Cabin John Auto Park (N. Bethesda Home Depot), Site Plan Amendment No. 81980017A

Staff Report Date: 4-16-18

Description

Request to amend an approved Site Plan to remove up to 15,870 square feet of vacant retail space to regrade and reconfigure an existing parking lot for 65 new spaces and ADA upgrades, associated landscape, outdoor lighting, stormwater management, parking lot circulation improvements and a parking waiver request.

Figure 3: Site Plan

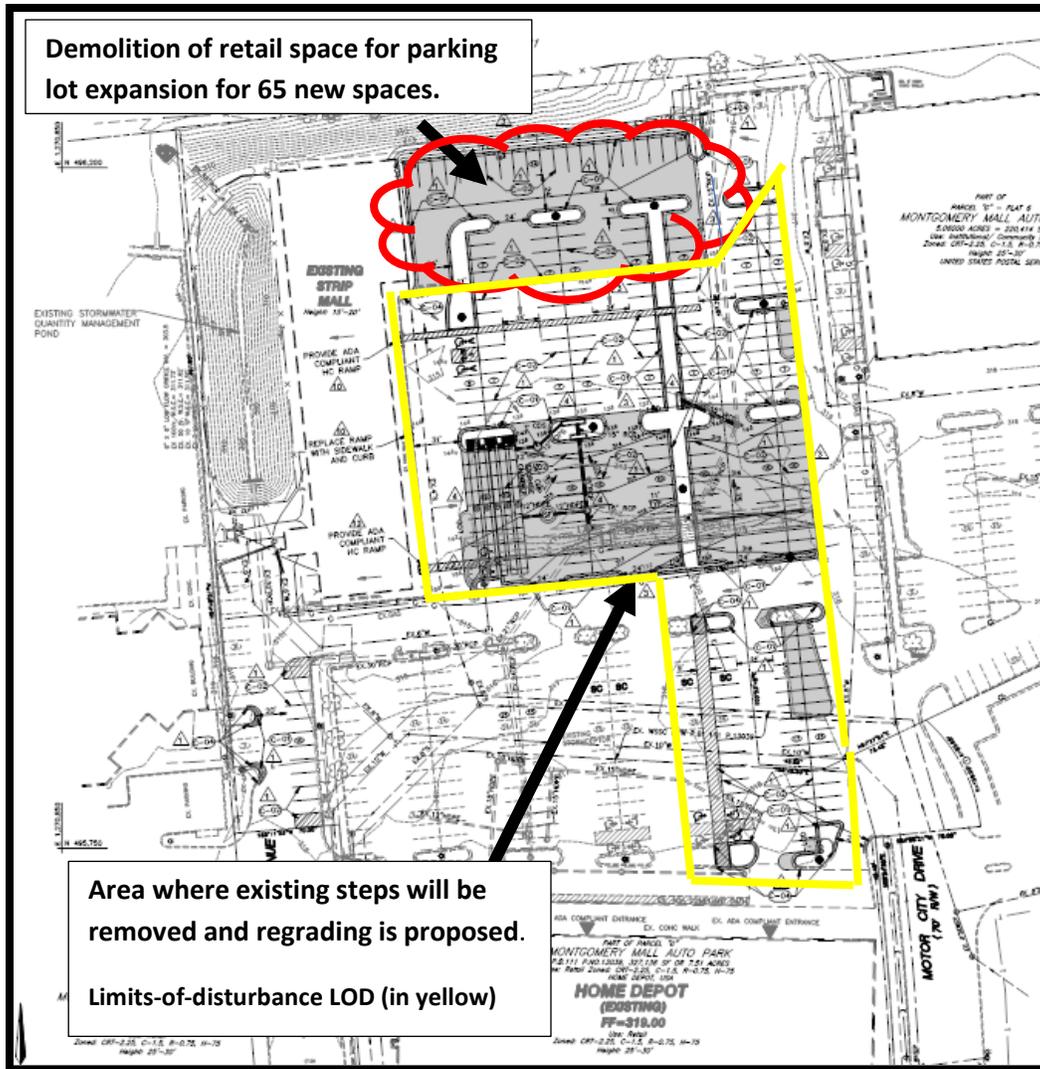
The Applicant recognizes there are parking challenges and constraints based on the existing conditions at the Home Depot, the shopping center and the adjoining USPS parking lots. The Applicant proposes to remove a portion of an existing building constructed under the development standards from the Property's former C-2 zoning, and to modify these parking lots to provide ADA-compliant upgrades and improve pedestrian and vehicular circulation. No new building construction is proposed. The Applicant intends to add more parking spaces and bring the Home Depot and the shopping center parking lot into ADA-compliance. These improvements include: regrading and reconfiguring the parking lot to eliminate existing steps at the south side at the parking lot's edge; adding 65 new parking spaces; improving vehicular and pedestrian circulation; and demolishing approximately 15,870 square feet of retail space at the north side of the shopping center (the demolition occurred in March 2018). Reconfiguration of the Property's parking lots improves pedestrian mobility by adding pedestrian crosswalks and ADA-compliant handicap ramps at existing sidewalks; providing a pedestrian crosswalk through the center of the Home Depot parking lot to connect to the store's entrance; and other minor adjustments to improve outdoor lighting, pedestrian and vehicular circulation as shown in Figure 3.

Fourteen existing trees inside the LOD will be removed and 11 new trees will be planted. Some existing light fixtures will be relocated and new light poles in the reconfigured parking lot are proposed.

Figure 4: Landscape Plan

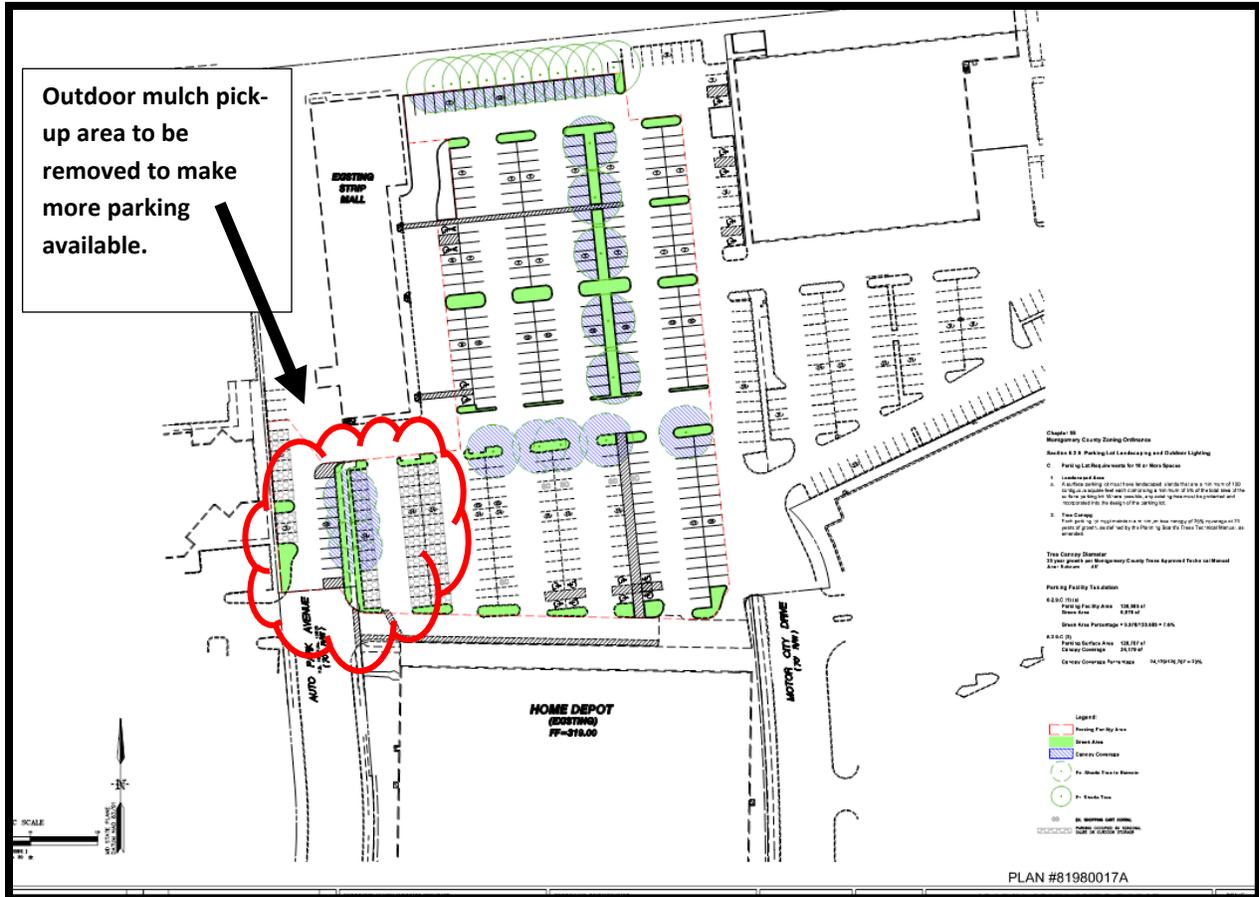
In Figure 4, the outdoor sales and mulch pick-up area is shown in the northwest part of the Home Depot parking lot. A field visit to the site last month found that one double-loaded parking bay and a second single-loaded bay and 11 additional parking spaces at the Property's west edge are used for the outdoor sales area. The outdoor sales area displaces 53 parking spaces.

The Landscape Plan includes removal of 14 existing trees around the parking lot and 11 new trees to be planted at the north end/new parking lot edge. The minimum five percent internal landscaping is met as demonstrated in the Landscape Plan in an exhibit with 7.6 percent.
